## 35-TYPE CONVERTER SETS — ADJUSTMENTS

*APPARATUS AFFECTED:* 35A, 35B, 35D, 35E, 35F, 35G and 35H Converter Sets.

- (1) To simplify adjustment methods and requirements.
- (2) To revise and update wiring diagrams.

**8.19 GEAR MECHANISM****(A) INTERMEDIATE SHAFT****REQUIREMENT**

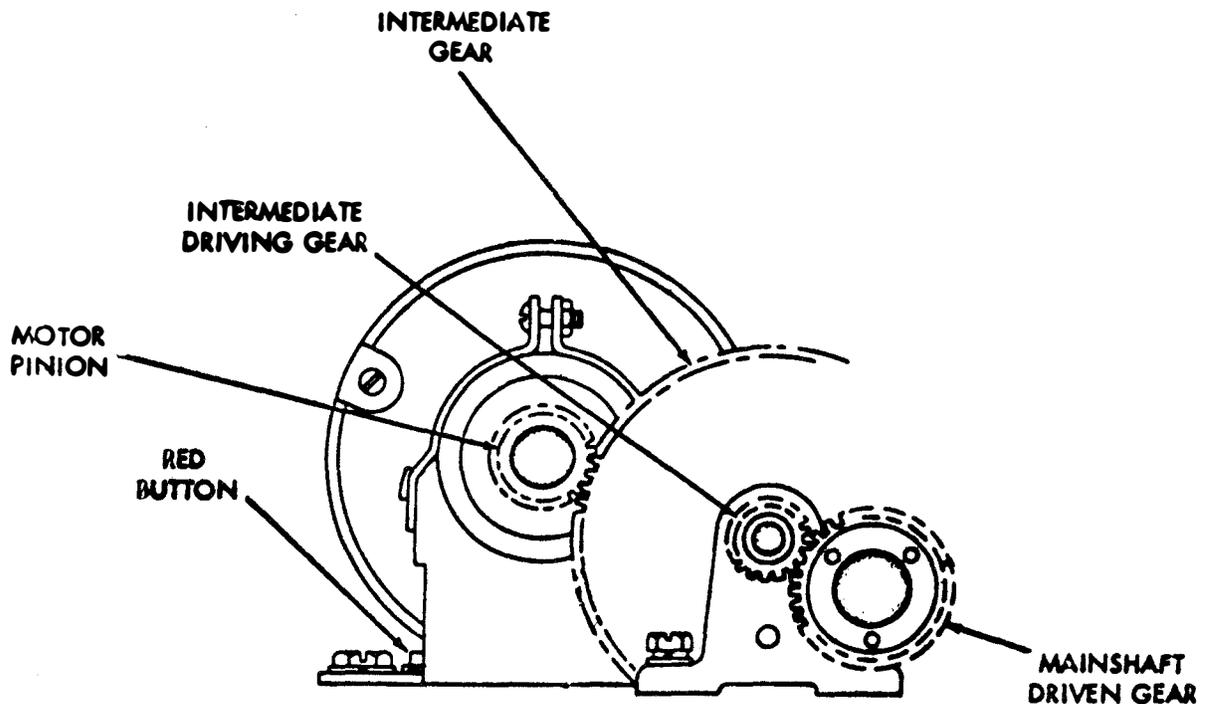
(1A) *Section 570-106-700, Issue 3, Page 30, Paragraph 3.19*

(A) Tape Reader Gear Backlash

The location of subparagraph (A) on page 30 has been changed and will read as subparagraph (B) Tape Reader Gear Backlash.

The requirement (A) Tape Reader Gear Backlash has been changed:

From: "Only a perceptible amount of backlash between main shaft driven gear and intermediate driving gear."

To: "Only a perceptible amount of backlash between main shaft driven gear and intermediate driving gear at point where backlash is least."

(B) Intermediate Shaft

The location of subparagraph (B) on page 30 has been changed and will read as subparagraph (A) Intermediate Shaft.

The requirement of Min. 0.015 inch—Max. 0.020 inch has been deleted.

"To Adjust" of new (A) Intermediate Shaft, has been changed:

From: To Adjust.

Position the intermediate shaft assembly to the forward plate loosened.

To: To Adjust.

Loosen the two intermediate gear bracket screws and position intermediate gear bracket.

The note to subparagraph (B) Intermediate Shaft, has been changed:

From: Note: Intermediate shaft adjustment required only on miniaturized base.

To: Note: In some cases, it may be necessary to loosen the motor mounting screws and position the motor to meet the requirements.

The new requirements are shown on attached sheet which should be used as temporary addendum to page 30, Section 570-106-700.

ONLY A PERCEPTIBLE AMOUNT OF BACKLASH BETWEEN THE MOTOR PINION AND INTERMEDIATE GEAR AT POINT WHERE BACKLASH IS LEAST.

LOOSEN THE TWO INTERMEDIATE GEAR BRACKET SCREWS AND POSITION INTERMEDIATE GEAR BRACKET.

**NOTE:** IN SOME CASES IT MAY BE NECESSARY TO LOOSEN THE MOTOR MOUNTING SCREWS AND POSITION THE MOTOR TO MEET THE REQUIREMENT.

ONLY A PERCEPTIBLE AMOUNT OF BACKLASH BETWEEN MAINSHAFT DRIVEN GEAR AND INTERMEDIATE DRIVING GEAR AT POINT WHERE BACKLASH IS LEAST.

LOOSEN THREE TAPE READER MOUNTING SCREWS AND POSITION TAPE READER.
